ARROWHEAD RANCH INFRASTRUCTURE

BRIDGE AND CHANNEL IMPROVEMENT

UNION HILLS DRIVE AT SKUNK CREEK

ADDENDUM NO. 1
TO
ARROWHEAD RANCH INFRASTRUCTURE
BRIDGE AND CHANNEL IMPROVEMENT
UNION HILLS DRIVE AT SKUNK CREEK

PHASE I UNION HILLS DRIVE DETOUR

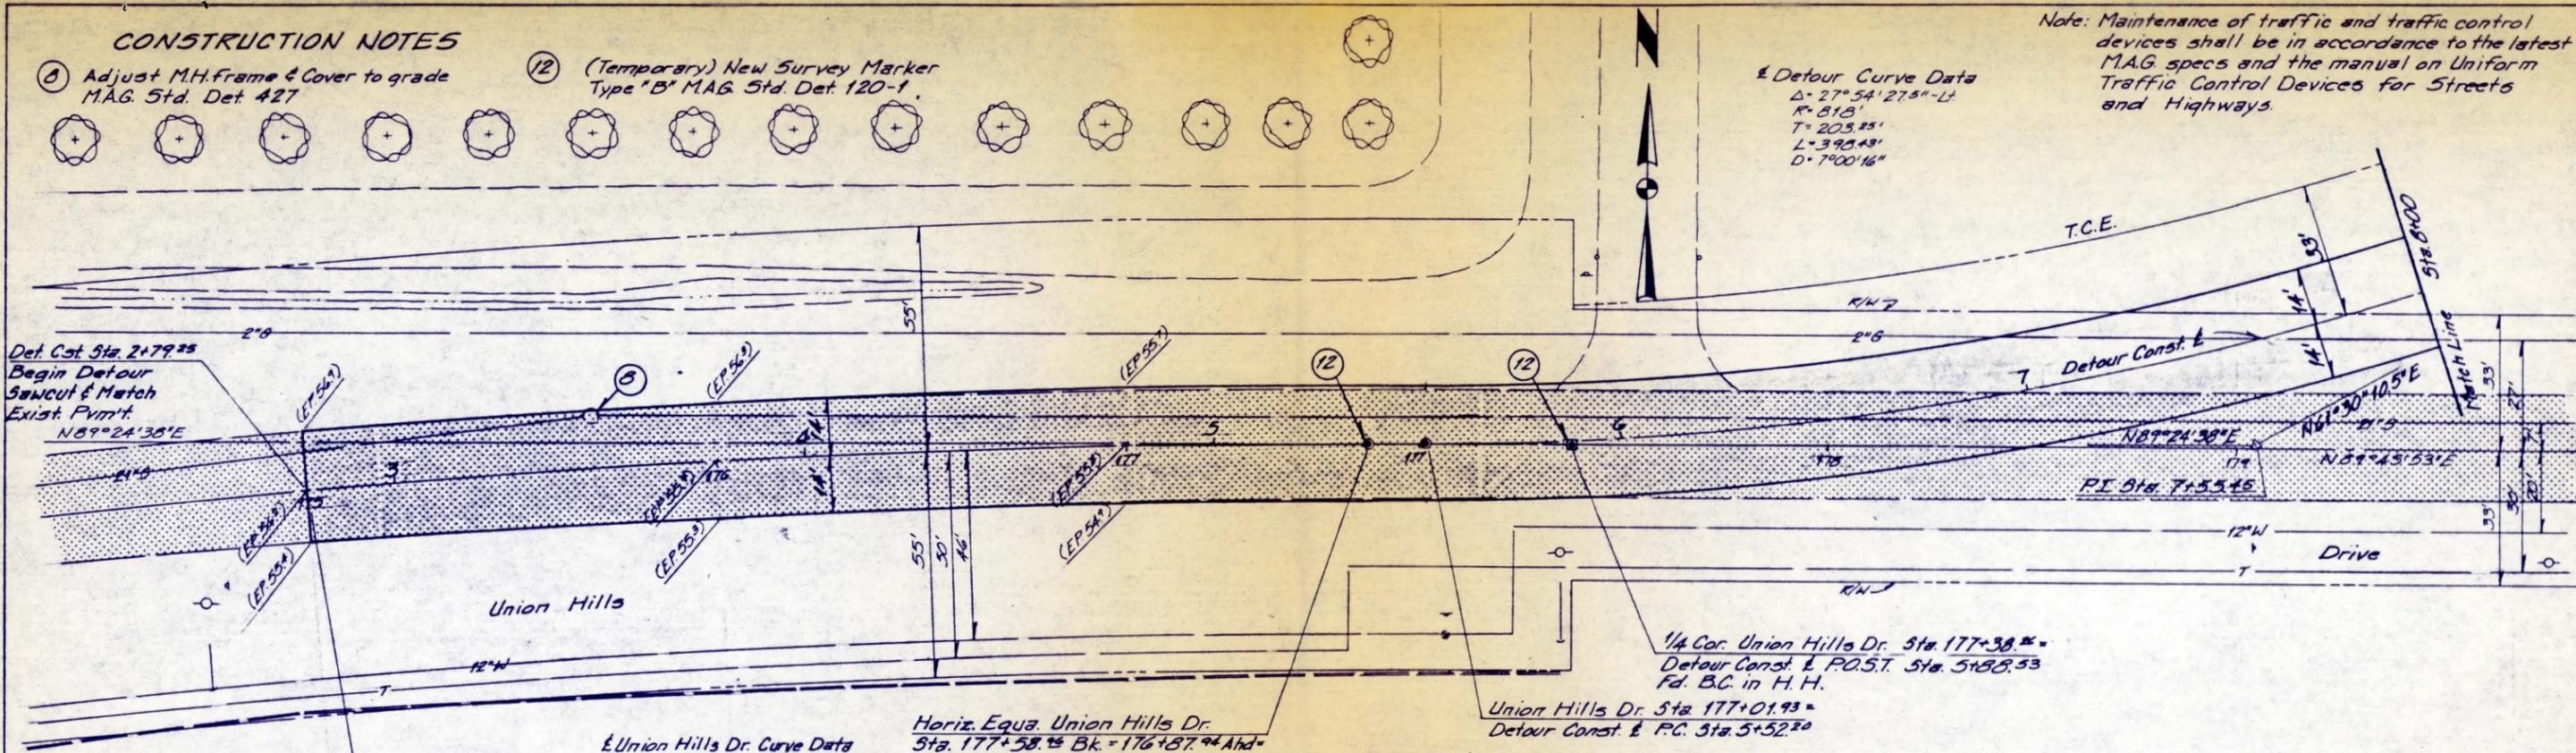
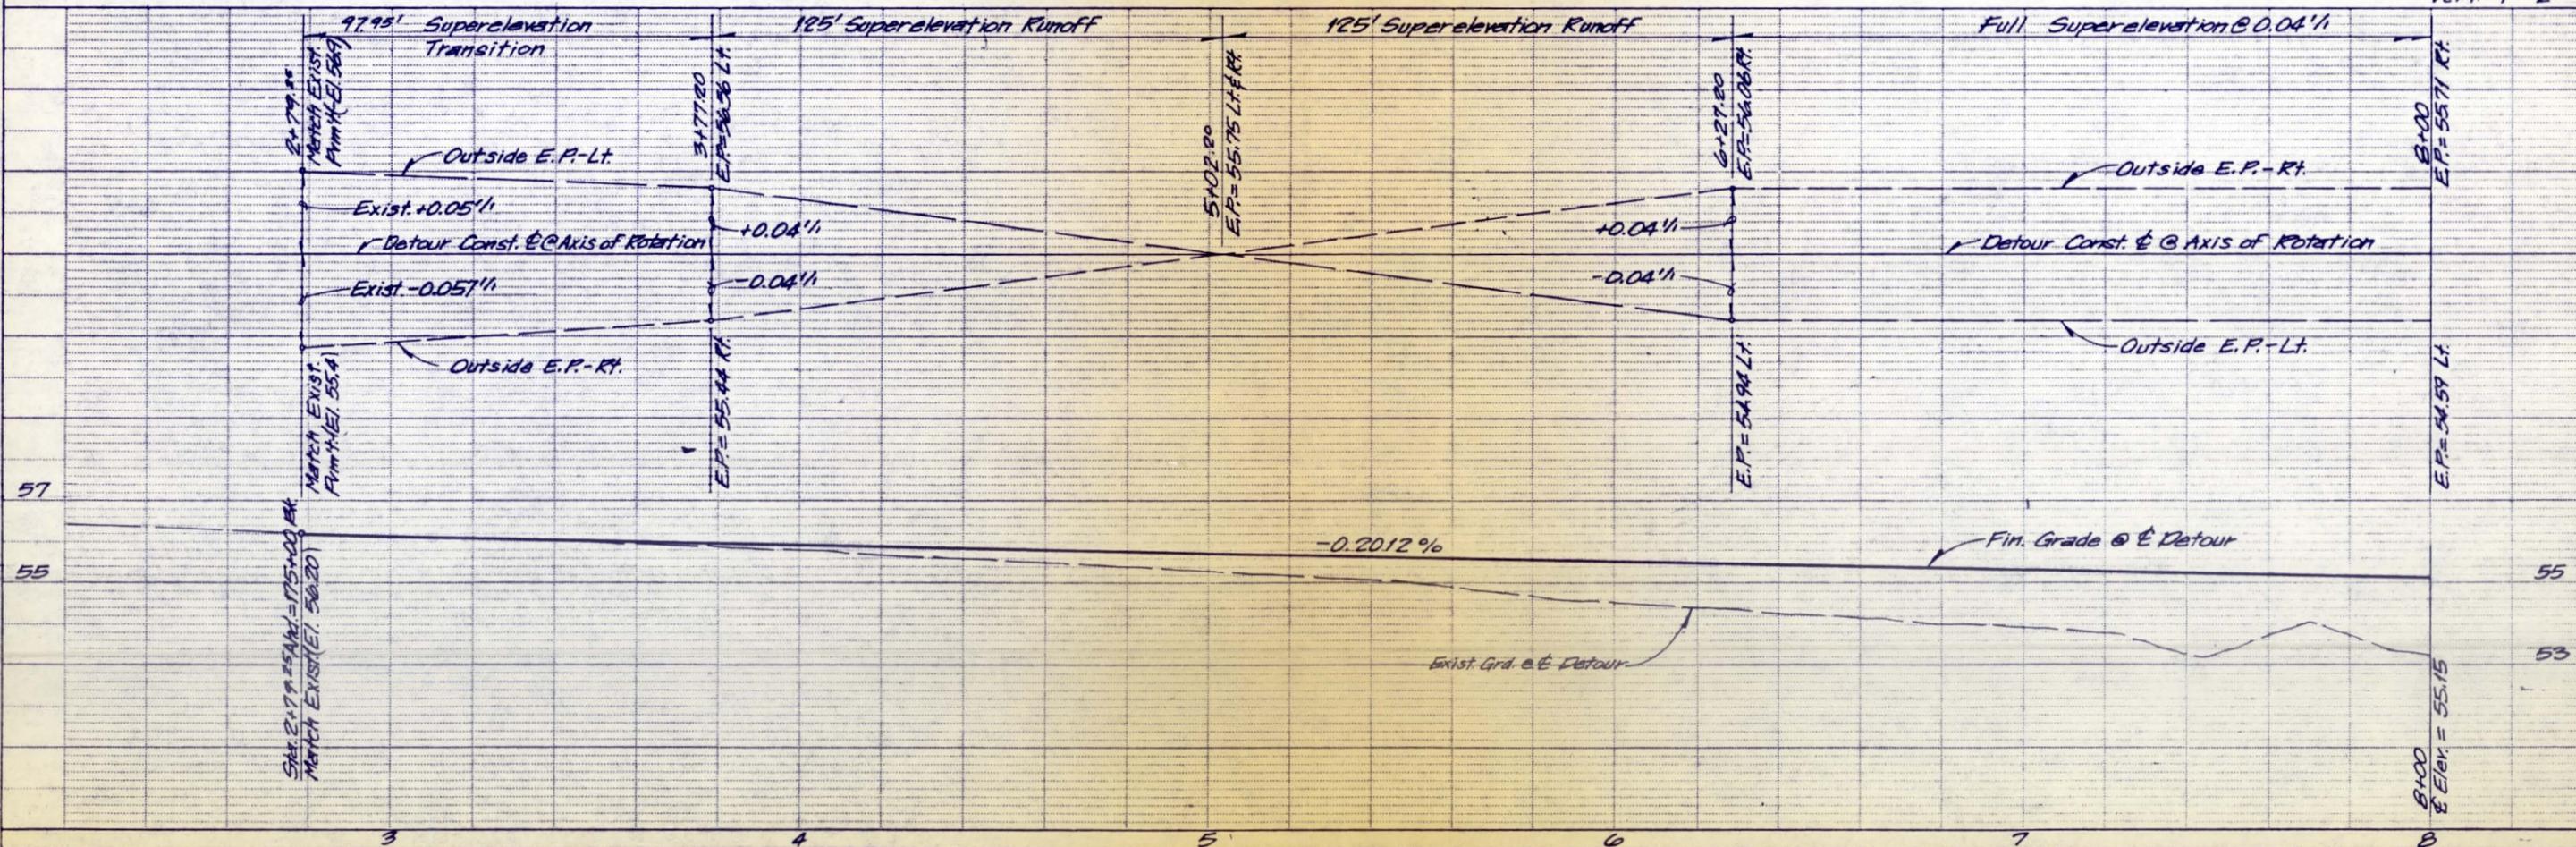
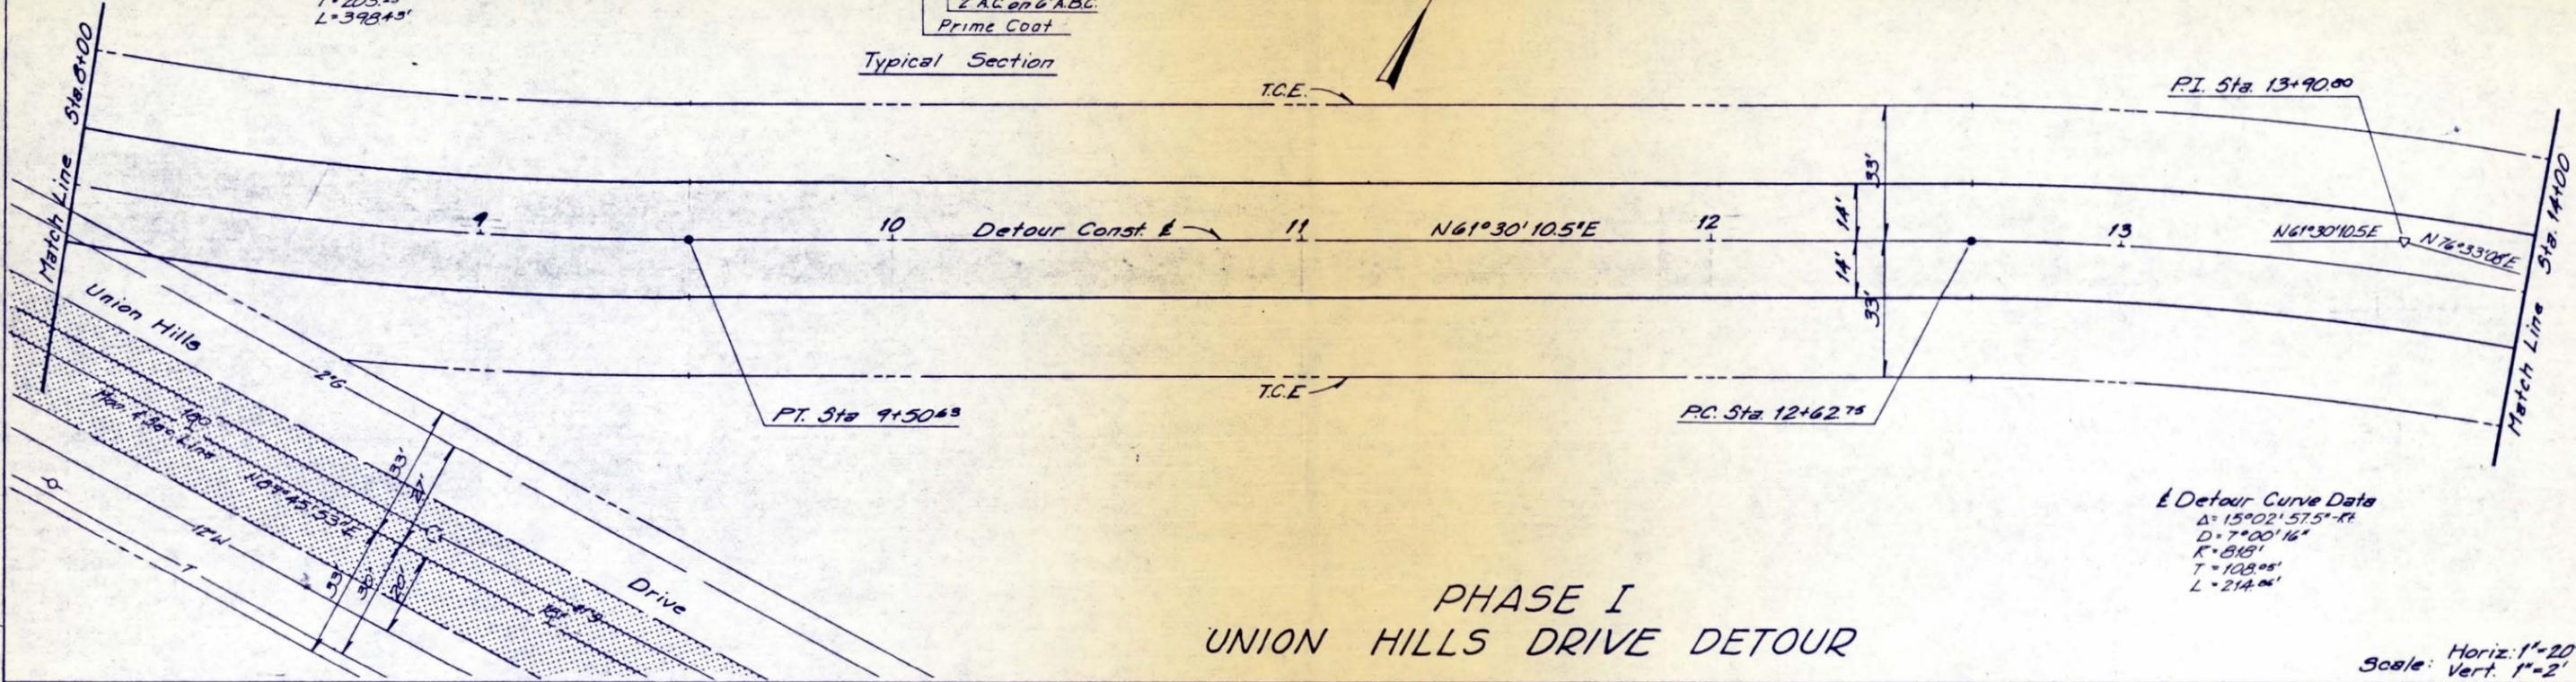
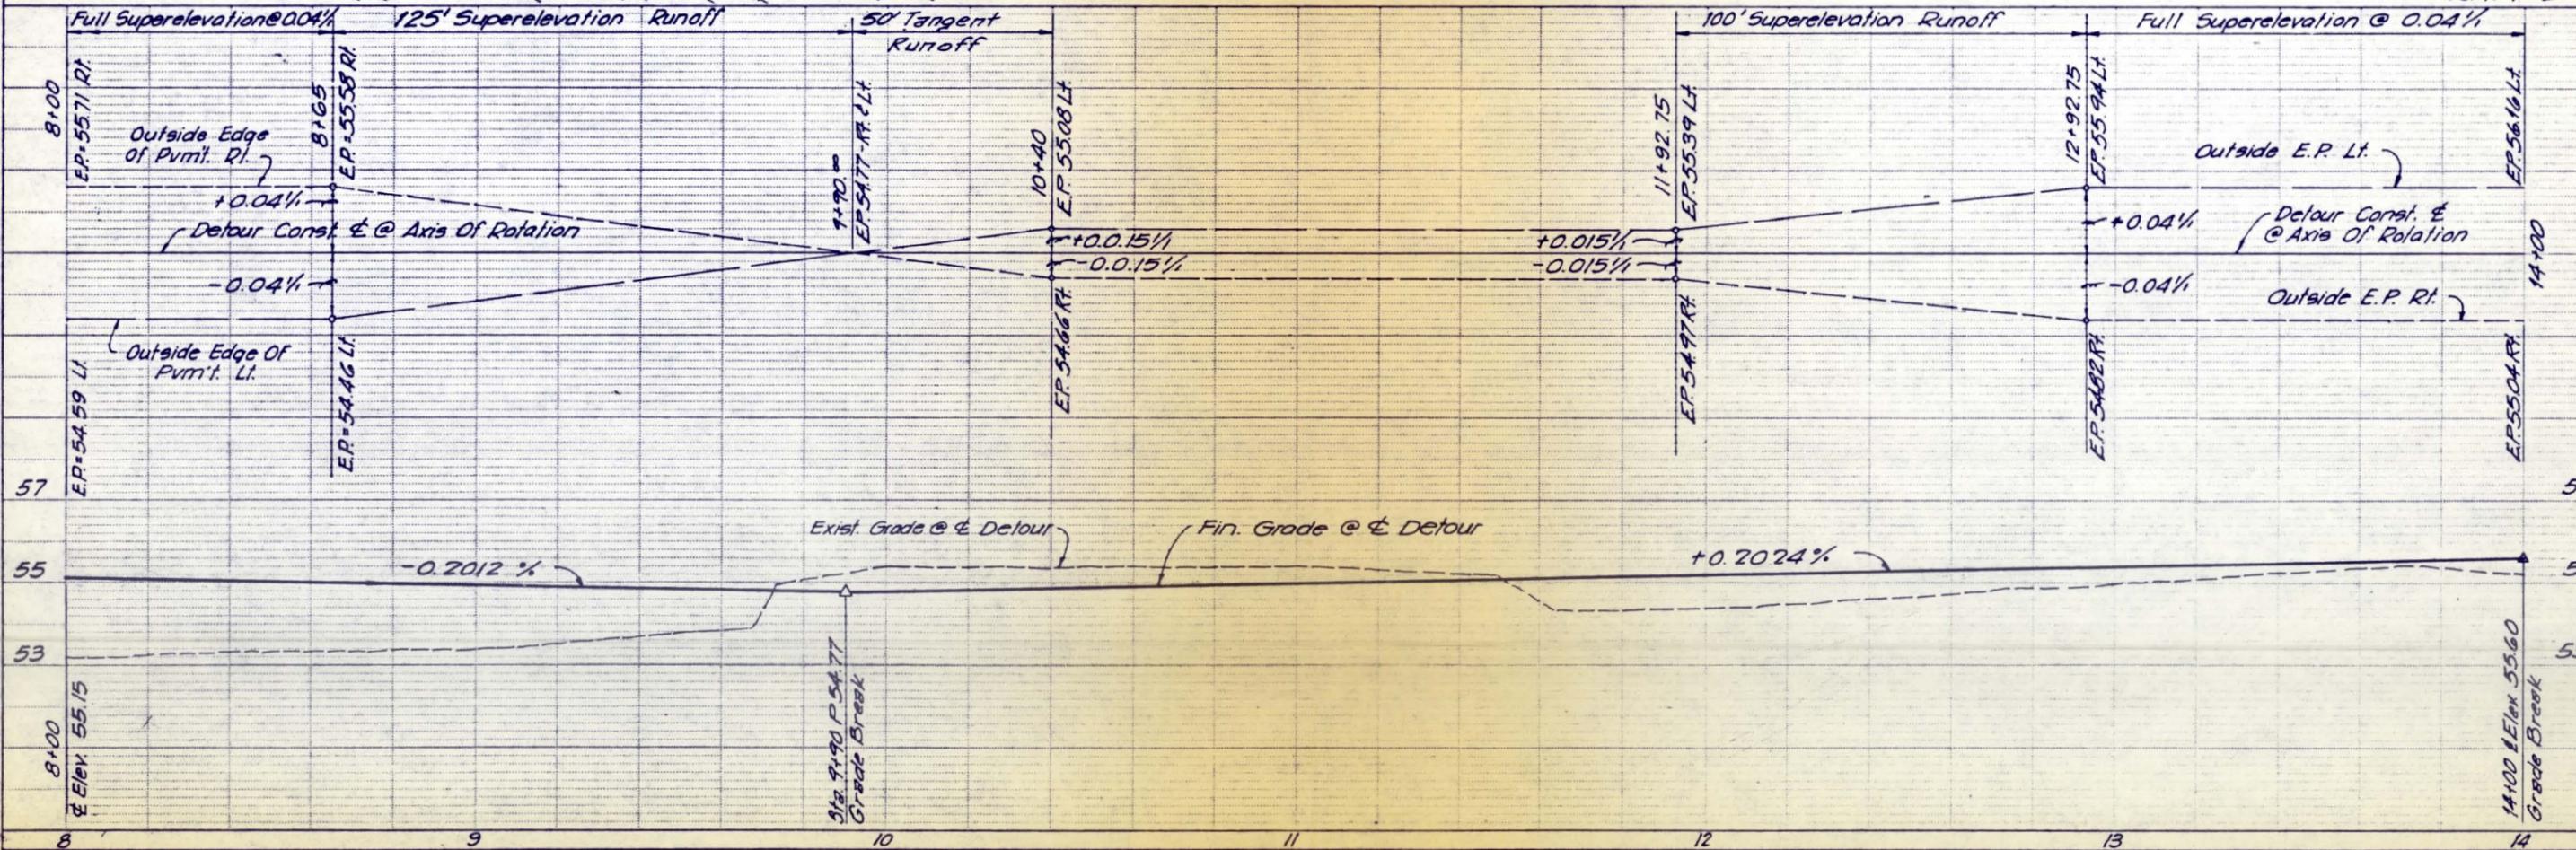
Delete Detour Sheets 2 through 6 from the Plans and insert therefor half-size Phase I Sheets 2A and 2B (new Plan and Profile Drawings) and Sheets 3 through 6 (which have new stationing) attached to this Addendum.
